Issue 18: What is Data Point's Point?

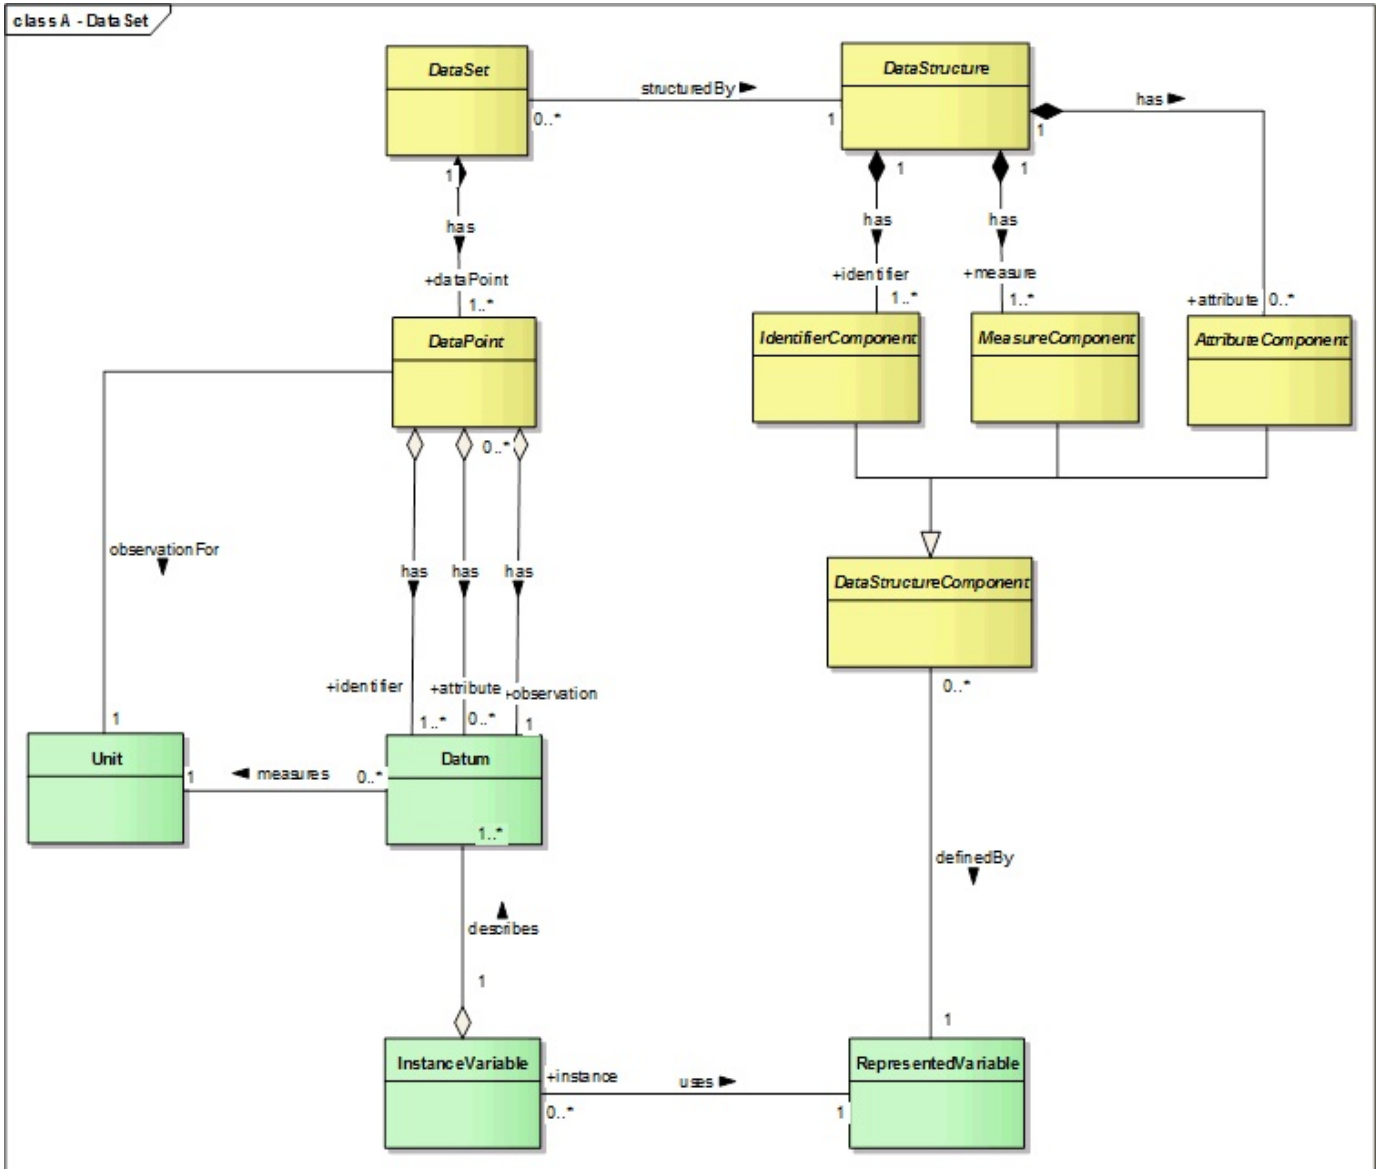
If we consider the above definitions of DataPoint and UnitDataPoint, then they say that it is a cell within a UnitDataSet. The example given within UnitDataPoint, and the corresponding class diagrams (ie fig 44, page 248) however, tend to indicate that DataPoint (just referring to the one for the rest of the discussion) is in fact a combination of information, which would be coming from multiple cells of data (ie, a 'row' of data).

If we go by the written definitions, that the DataPoint is a cell of data, then the example should show that it is the container to hold age in years (43, as per example above), not the combination of social security number and age. There would be another DataPoint which would hold the social security number (1212123) for that Unit.

Within the diagram, DataPoint has Datum (value) related to it in three ways - as an identifier, an attribute, or an observation (although this should be measure, based on the name of the equivalent Data Structure Component). According to the cardinalities in the picture for these three relationships, a DataPoint MUST have at least one identifier, MUST have at least one measure/observation, and may have one or more attributes. This seems to give an indication that the DataPoint covers more than one 'cell' of data. The example also indicates that it is a combination of information - as the DataPoint includes both the age and the social security number for the unit.

Proposal 1: We assume that the definitions of DataPoint, UnitDataPoint and Datum are correct, which means that the cardinalities between DataPoint and Datum are incorrect in Fig. 44?

Therefore, a DataPoint represents a single cell of data, and so the example has two DataPoints - one for age (43) and one for social security number (1212123).

Proposal 2: We assume that the definitions are incorrect, and the cardinalities in fig. 44 are correct. Therefore, a DataPoint represents all the data for a single Unit (ie, it is the whole 'row' of data, including both the age (43) and the social security number (1212123) for the Unit.

1. Is the information shown in fig. 44 only correct for dimensional data, and so is wrong in the case of unit data?
2. A diagram showing the relationships and cardinalities between UnitDataPoint, UnitDataSet, UnitDataRecord and Datum would be helpful in clarifying things (ie, a combination of the information that is currently split between fig 44 and fig 45 in GSIM v1.0 (pages 240 and 250 respectively).
